To: **Planning Commission**
Through: **Ben Boike, Community Development Director**
From: **Melissa Houtsma, City Planner**
Date: **July 19, 2022**

Site Plan and Preliminary/Final Plat Review for a Small Building Expansion at 1250 Oakdale Ave (St. George Church) – SRa, Inc.

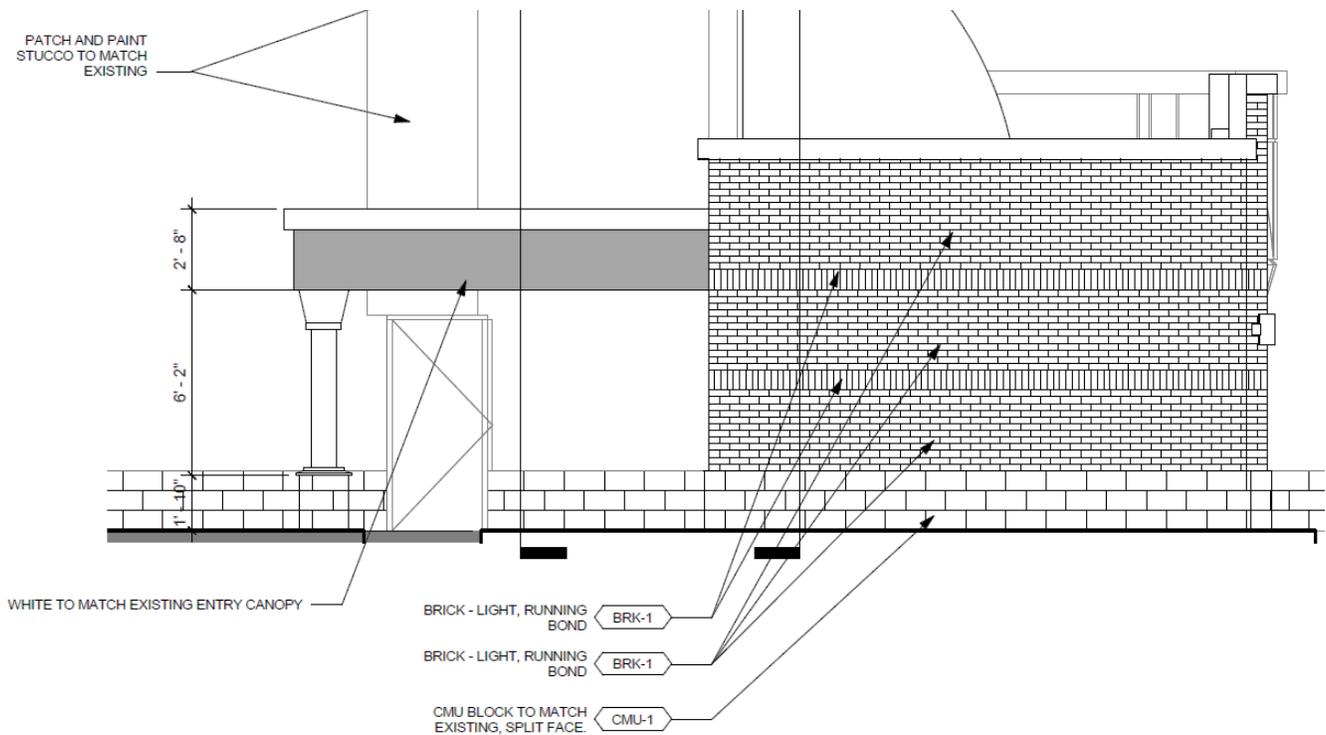
The current parking lot lay out has 105 parking stalls, after the construction of the addition that number will be reduced to 102 stalls. The only stalls that will be changed by the addition are the west stalls in the middle parking row, they will change from a combination of parallel parking and 90 degree angled parking to all parallel parking stalls on the west side of that row.

The proposed parking stall dimensions for the 90 degree parking stalls are 9 feet wide by 18 feet deep, with a 24 foot wide drive aisle in between. The parallel parking stalls are shown as measuring 9 feet wide and 20 feet deep. Since the code requires parallel parking stalls (0 degree stalls) to be 23 feet deep, city staff is recommending the site plan be amended to make the five parallel parking stalls be 23 feet deep.

Since current code requires that curbed islands, with both landscaping and irrigation, be placed at the end of every row of parking, staff is recommending that curbed islands, both landscaped and irrigated, be incorporated in the areas shown in green. Each island shall contain at least one quality tree as well as grass, shrubs, or similar ground cover that is not asphalt or concrete. This was originally included in the 2001 site plan, but was ultimately removed to allow fire and emergency vehicle access. This is no longer an issue since the turning radii of fire engines has improved and the northern portion of the site can now be accessed through the shared access easement from St. Croix Lutheran's parking lot.

1. The applicant shall apply for an obtain all necessary permits, including those from the City of West St. Paul as well as those from the Dakota County right-of-way permitting office.
2. The site plan shall be amended to accommodate the five parallel parking stalls measuring 23 feet deep,
3. The site plan shall be amended to incorporate curbed islands at the ends of the western three parking rows on the northern portion of the site, the islands shall be irrigated and each shall contain at least one quality tree as required by code.
